RE: Application of Orange County-Poughkeepsie Limited Partnership d/b/a Verizon  
Wireless Proposed Public Utility/Personal Wireless Service Facility on existing  
water tank located off Kings Highway

We are in receipt of the report and recommendations prepared by the Planning Board's consultant Clint Smith, P.E. dated May 14, 2018. On behalf of Verizon Wireless (the "Applicant"), I submit the following response to the specific recommendations made in the May 14<sup>th</sup> report which I have numbered below for the Planning Board's convenience. Please note that the responses provided below regarding radio frequency issues were provided by Verizon Wireless' RF Engineer, who was not available to prepare a stand-alone response due to his need to travel from Rochester to Chester for tonight's Planning Board meeting.

## ATTACHMENT 1a

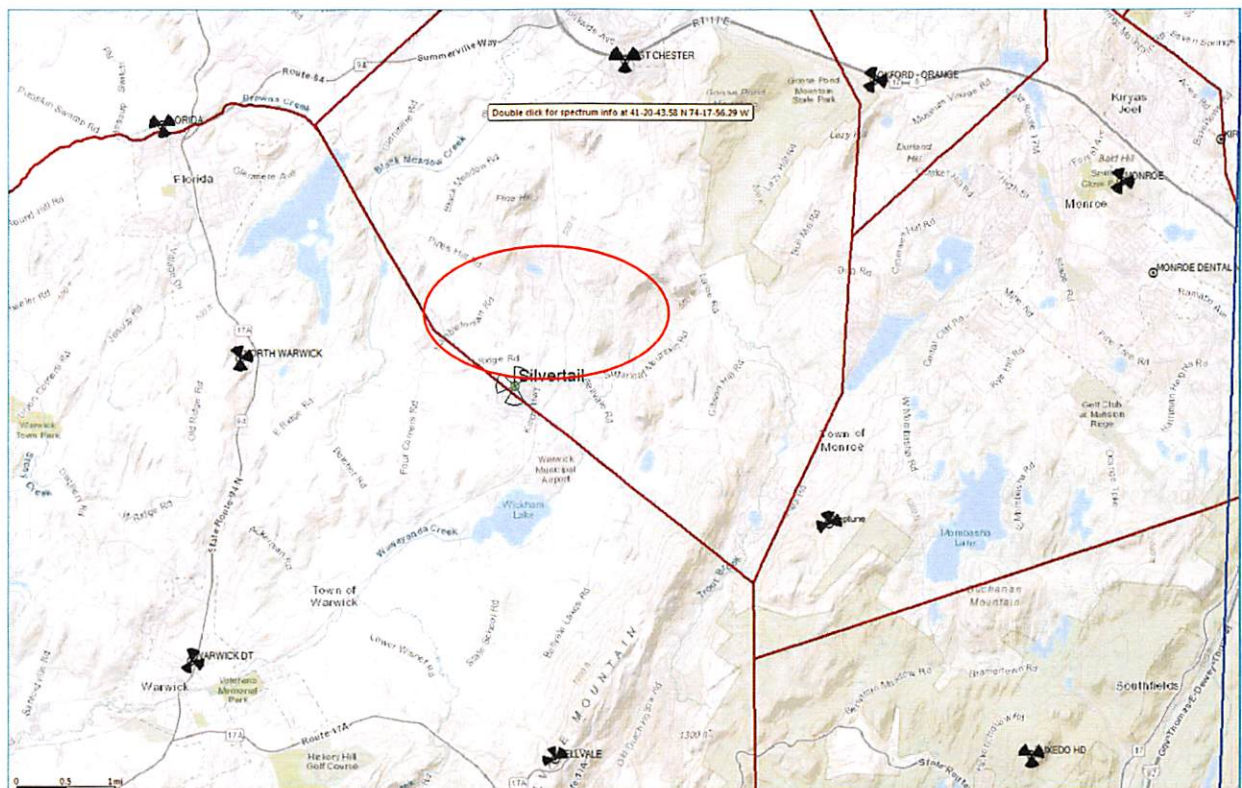
Recommendation No. 2: Provide the existing sites surrounding the search ring propagation plot with the search ring included.

Recommendation No. 3: Provide the existing and proposed site Propagation Plots with Search Ring included.

Response: See **TAB 2** which includes a new Attachment 1a to the Site Selection Analysis showing the search area overlaid on the same coverage map (base layer) to establish scale for coverage slides appended to the Applicant's Site Selection Analysis.

Response: See response to Recommendation No. 2 and the new Attachment 1a which shows the search area on the same scale as the proposed site Propagation Plots.

### ATTACHMENT 3a

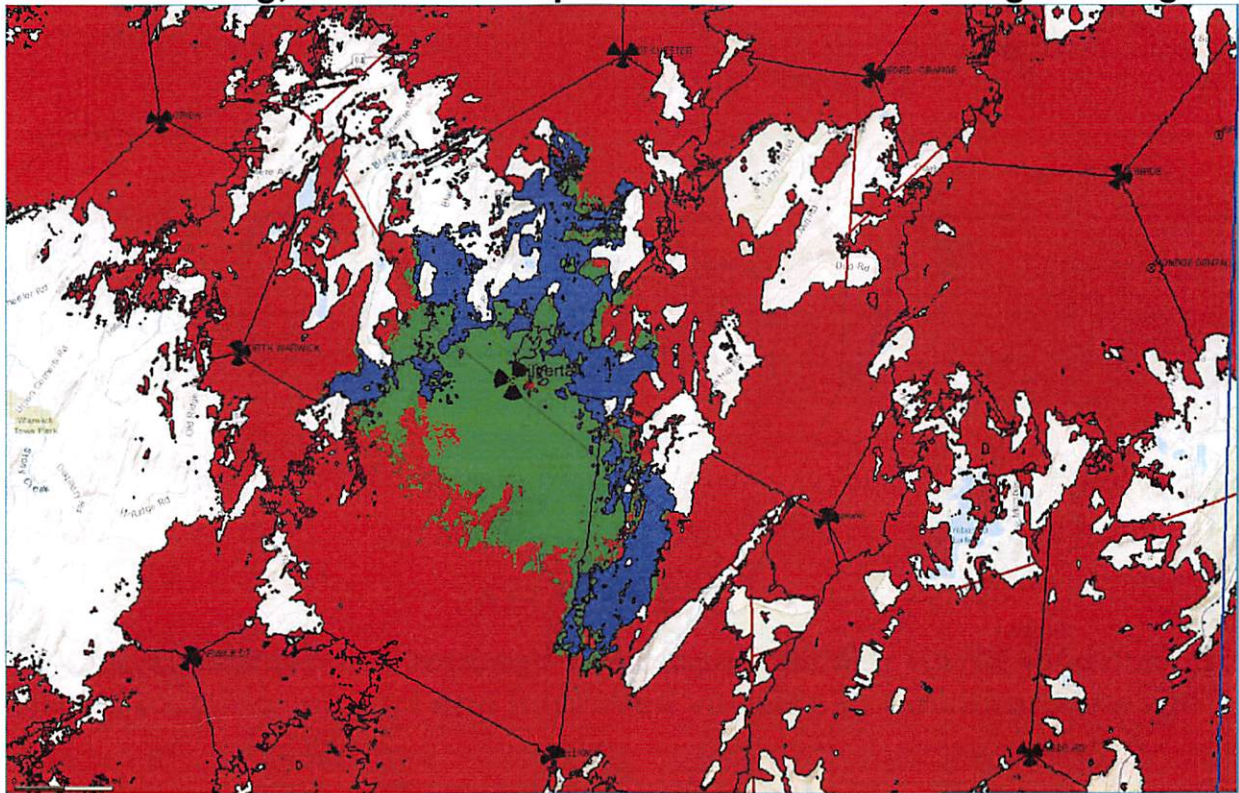
Recommendation No. 5: Provide a propagation plot showing existing in-building coverage problems with the search ring included.

Response: See **TAB 3** which includes a new Attachment 3a to the Site Selection Analysis that shows an area identified as "improved variable in building coverage.

## ATTACHMENT 2a

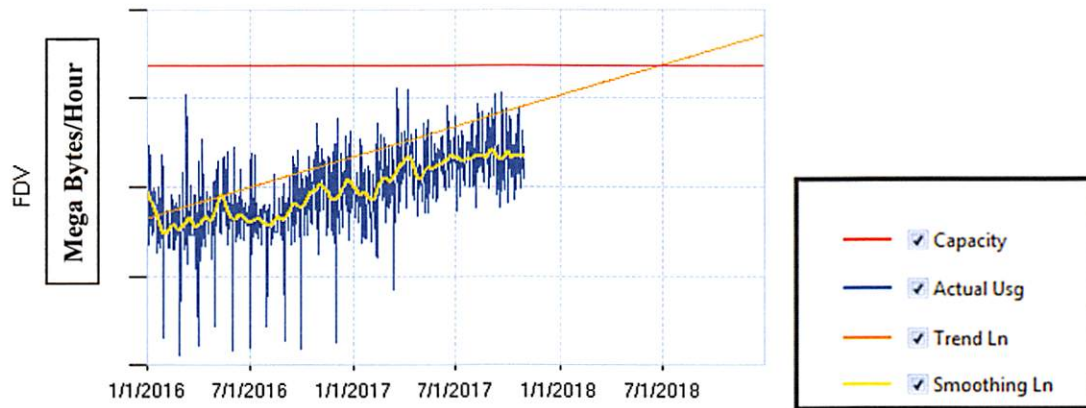
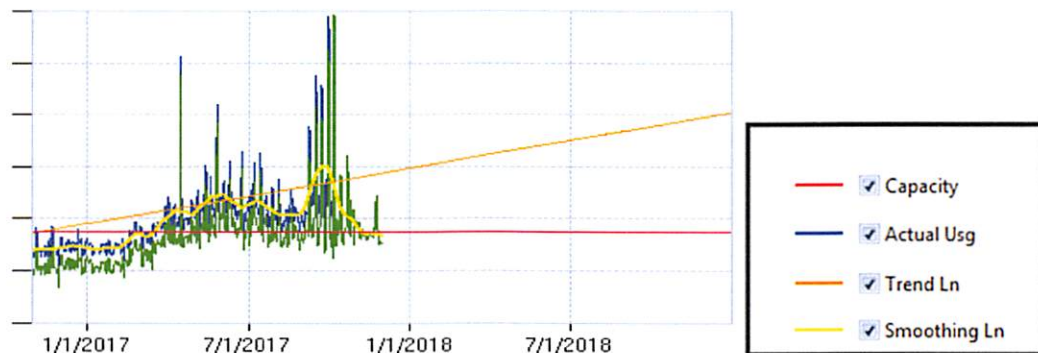
Recommendation No. 7: Provide clarification on the Forward Data Volume (FDV) plot in Attachment 2 from the December 8, 2017 Search Ring Justification Report.

Response: See **TAB 4** which includes the new Attachment 2a which is the Average Schedule Eligible Users (ASEU) (Supplement to FDV).
